CITY OF DADE CITY
NEW RESTROOMS

CITY OF DADE CITY - NEW PARK RESTROOMS
FINAL COLOR SCHEME

CITY OF DADE CITY
PARK RESTROOMS
37800 CHURCH AVENUE
DADE CITY, FL 33525

FLOOR PLAN,
REFLECTED CEILING
PLAN

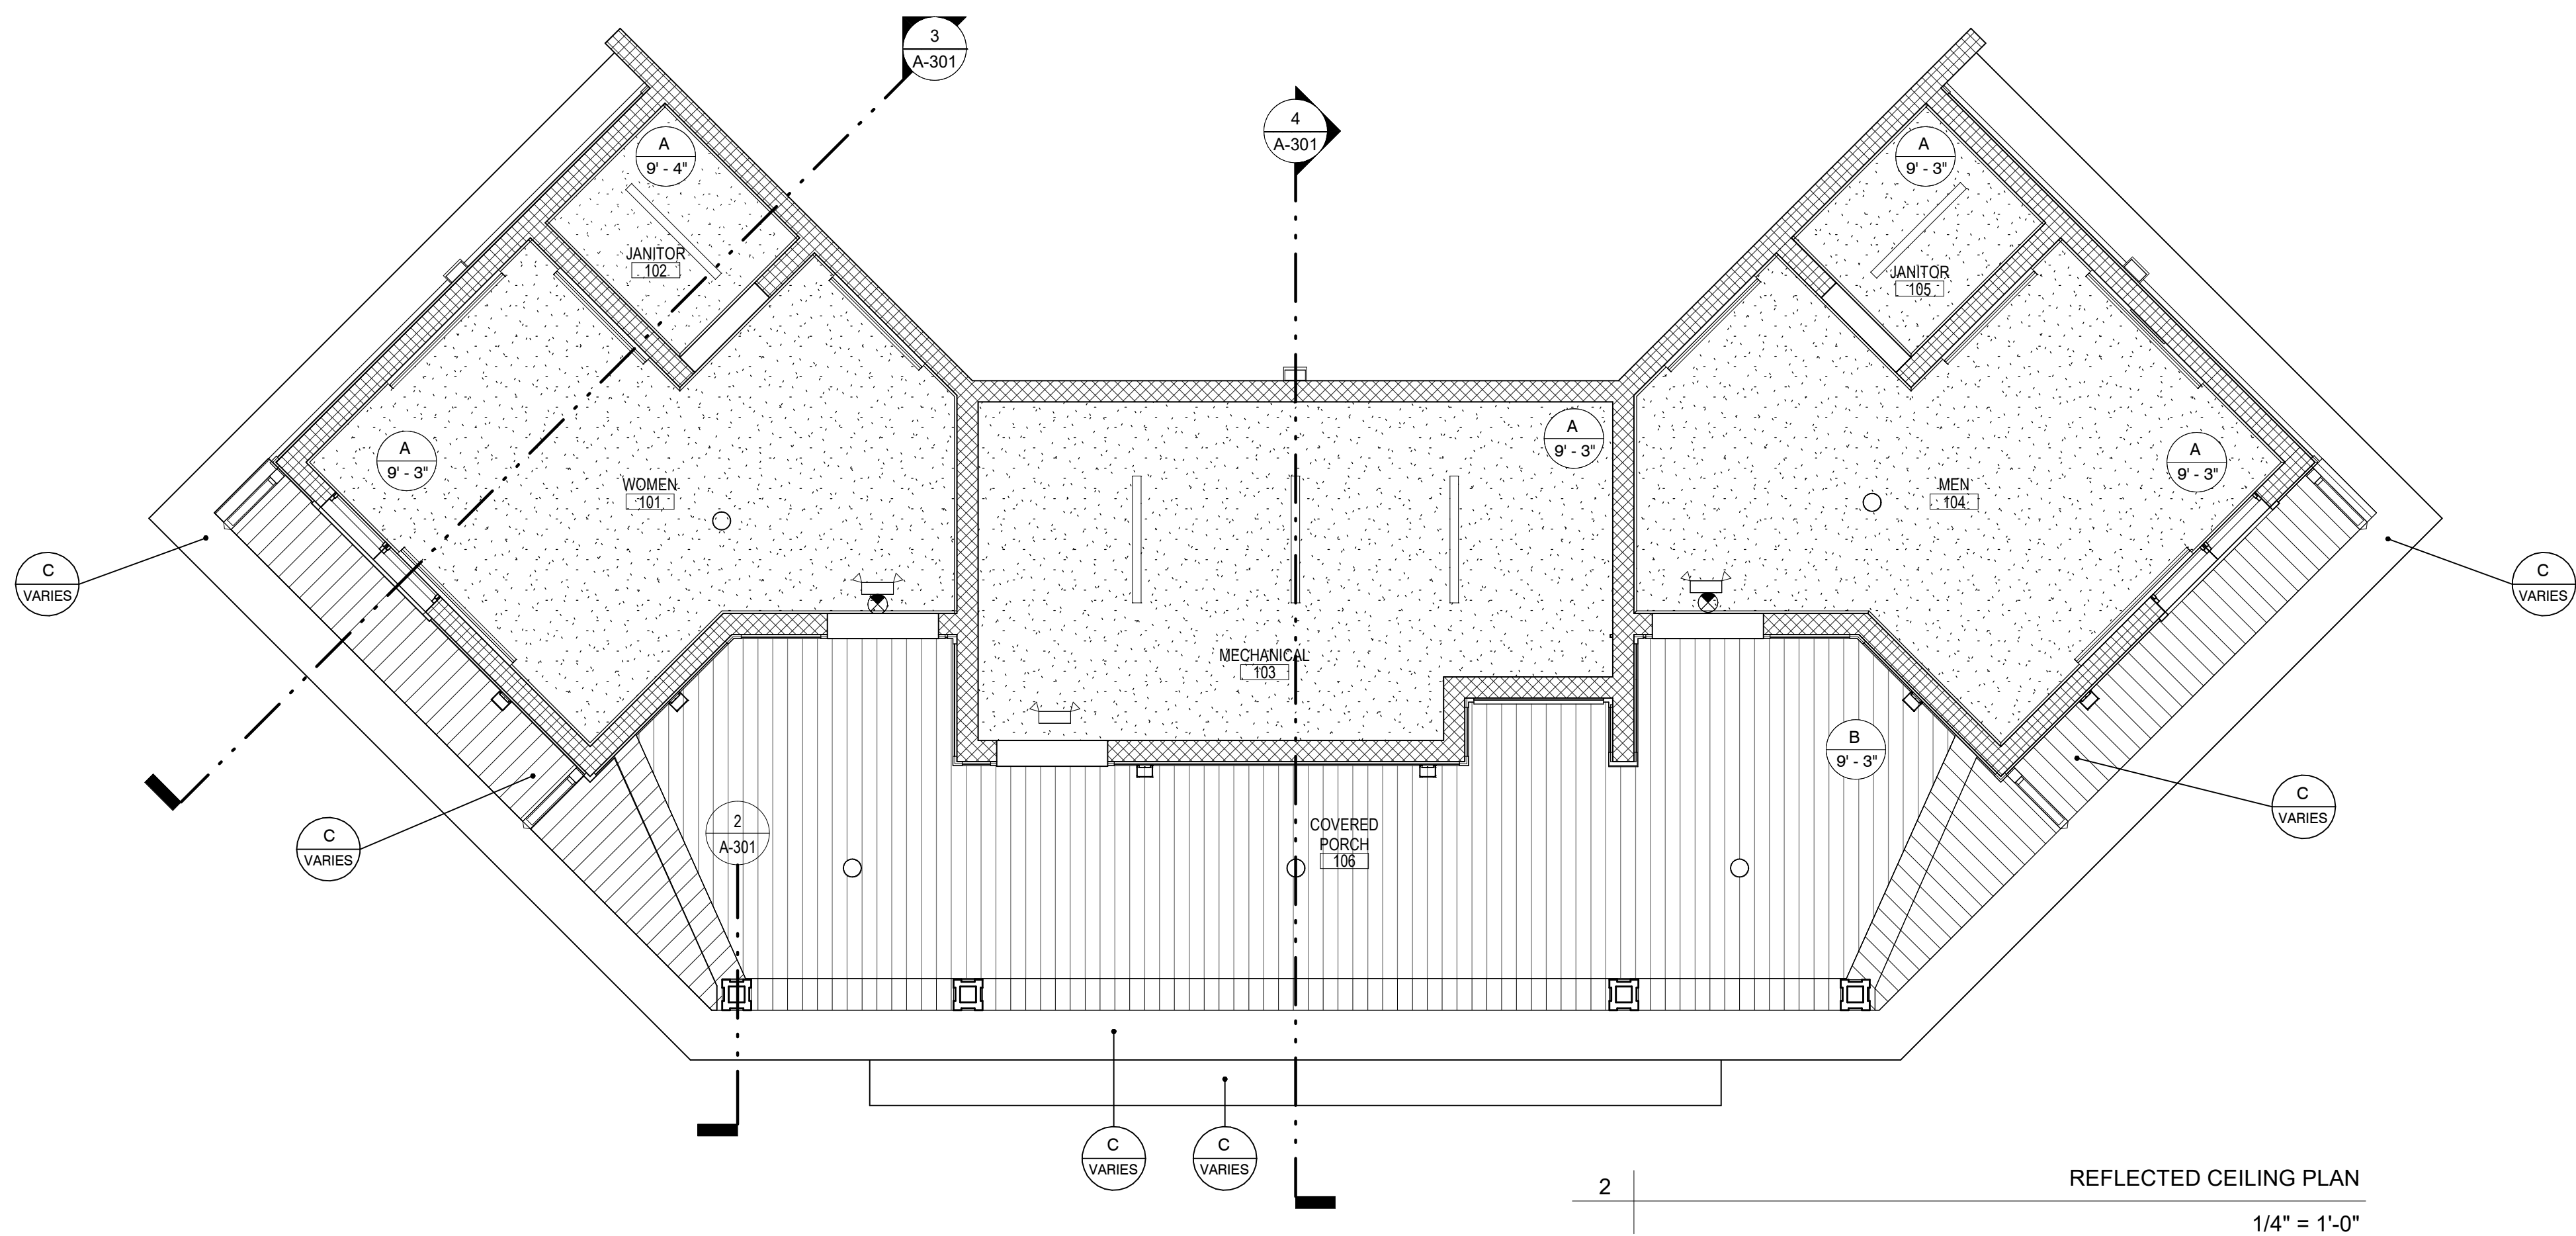
-Relocate the Janitors sinks to the Mechanical Room.
-Change to the 2 Janitors sinks in the each bathroom to a changing room and place the folding diaper table in these rooms.
-Change the Block wall to a toilet partition wall (Red Walls)

EXTERIOR ELEVATION

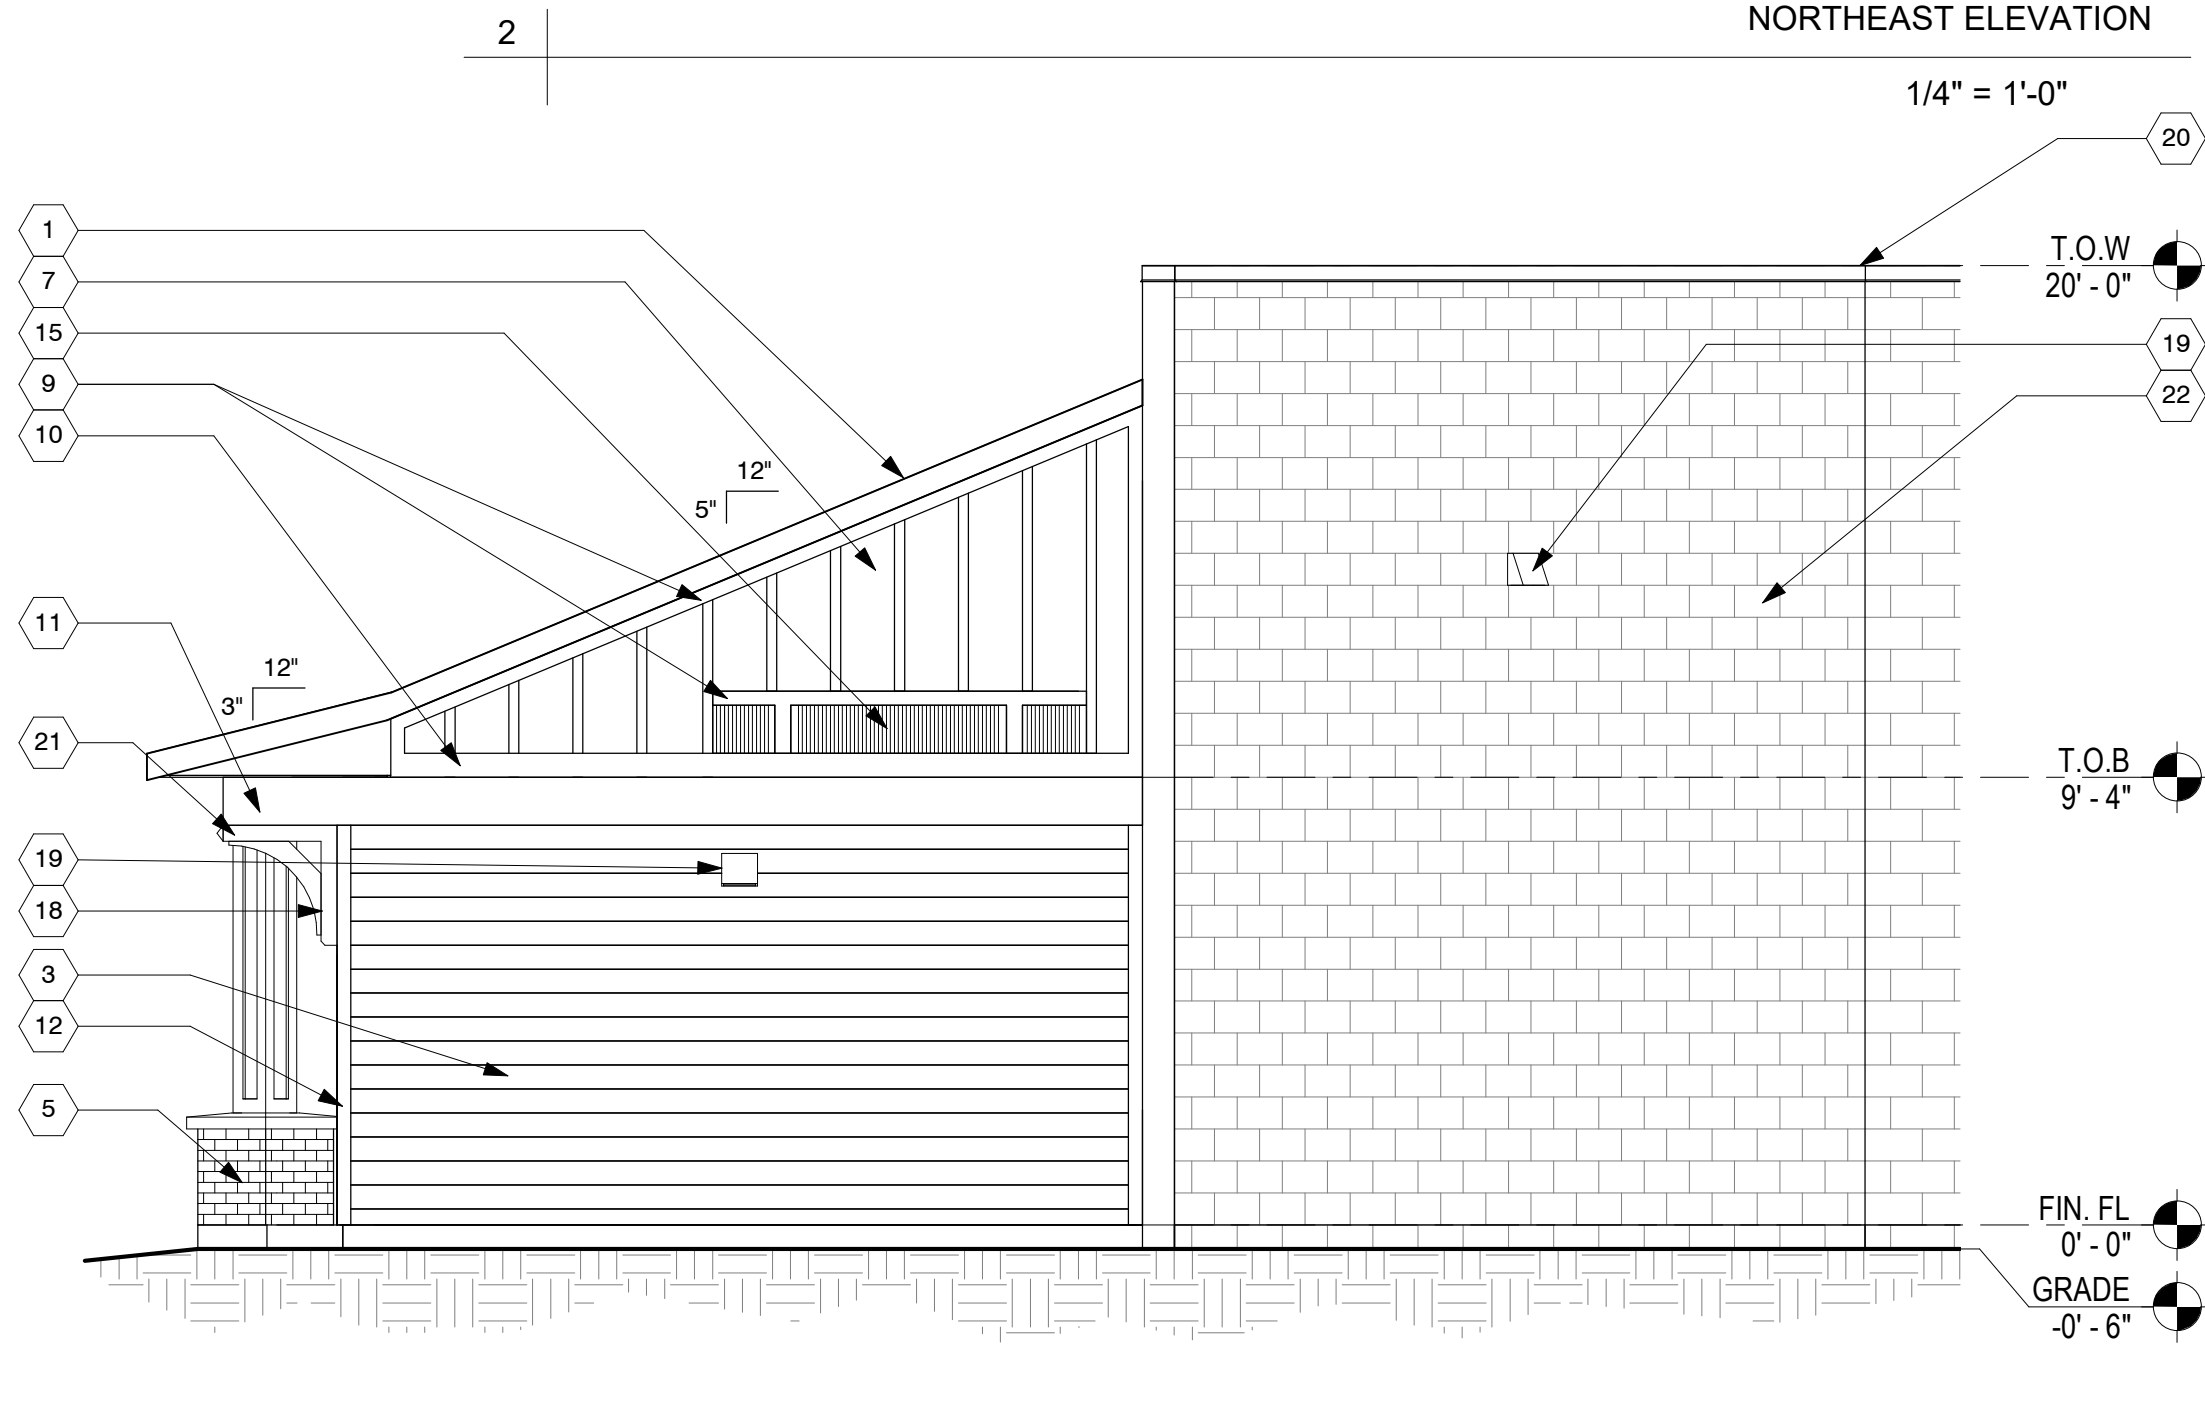
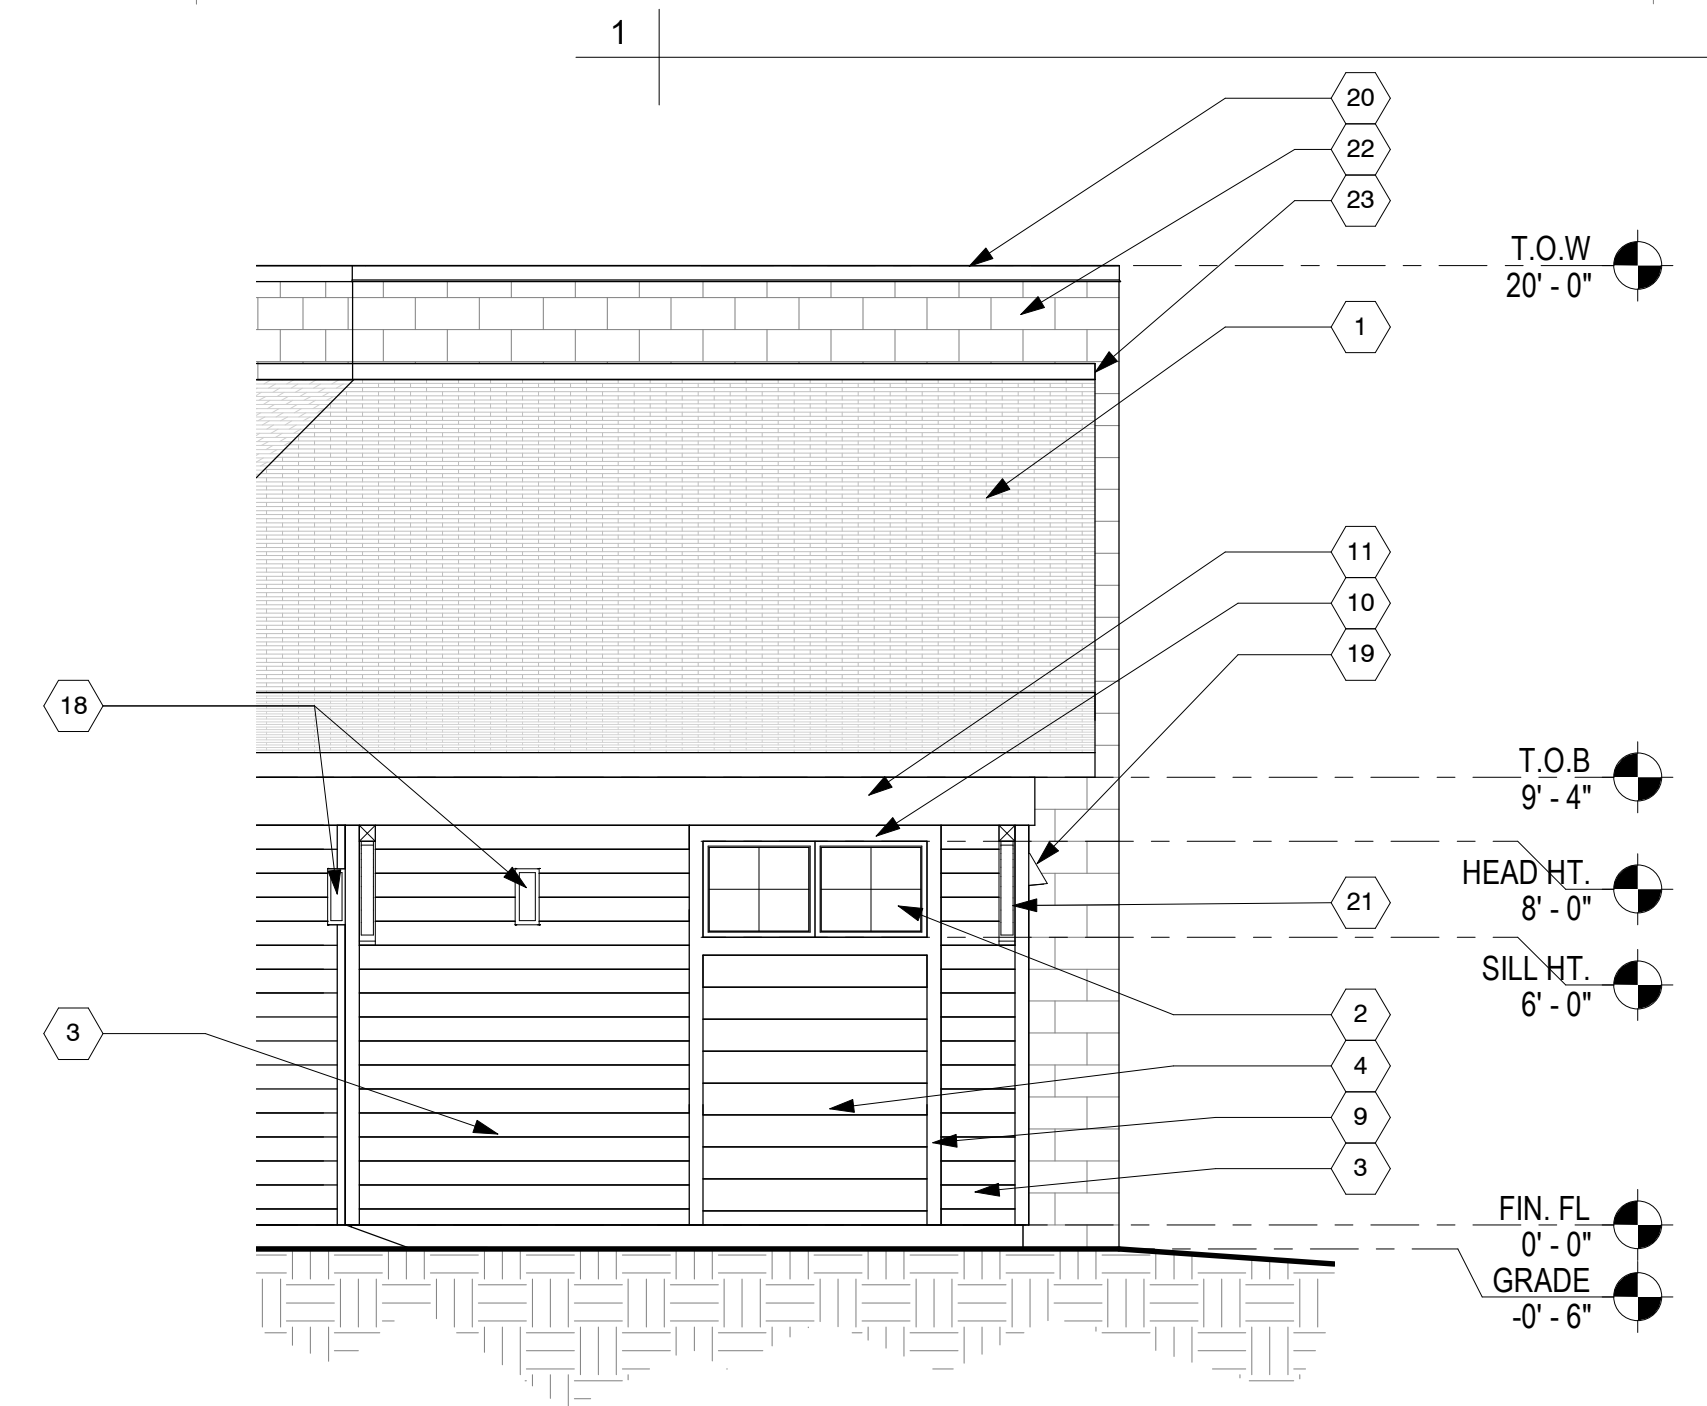
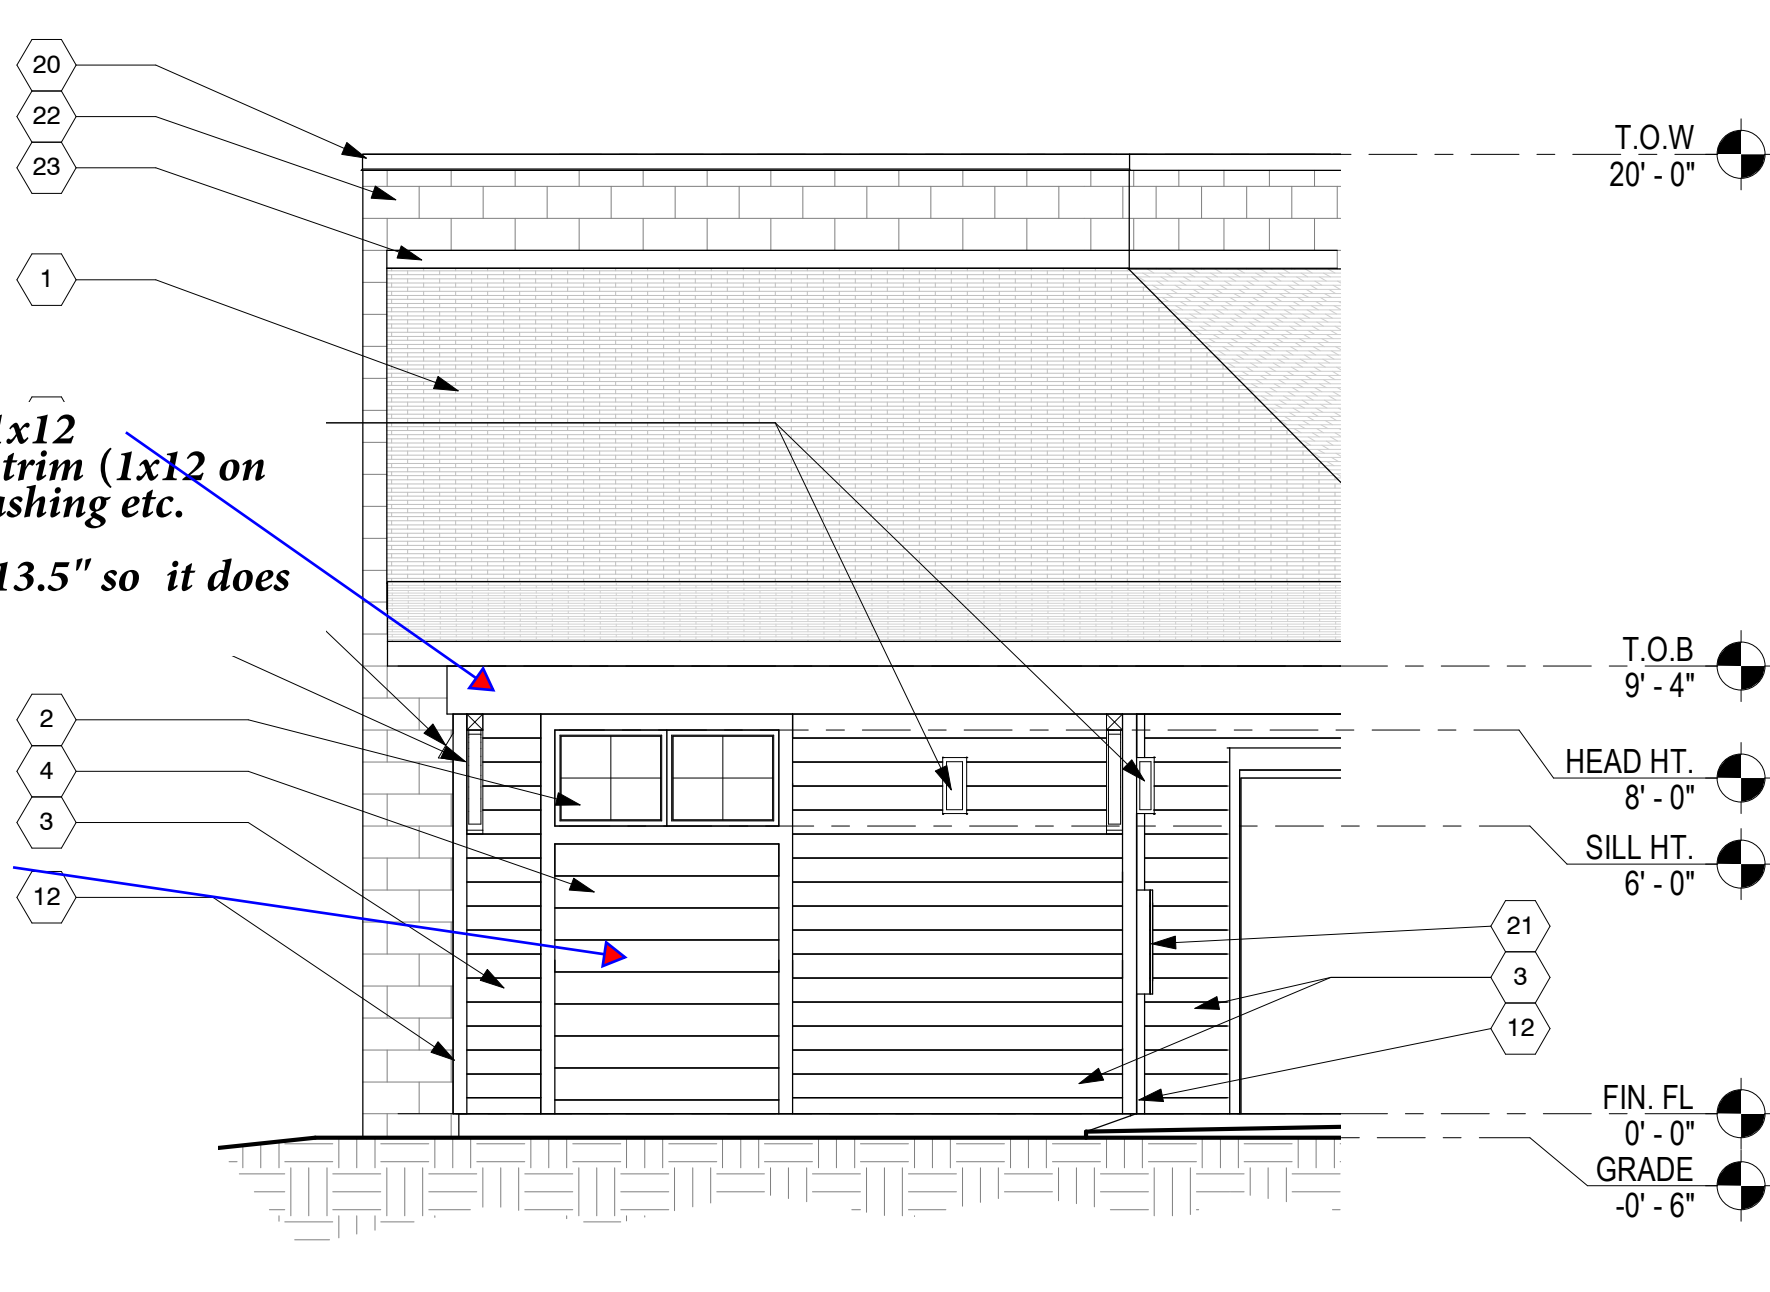
install a 1x4 top trim on the sides not 1x12 and a 1x6 on the gables. Back to back trim (1x12 on top of the 1x6) is challenging with Z flashing etc.
The beams in front PAD out to be +/- 13.5" so it does not match the 1x12

We are keeping this detail with wider exposure Looks good
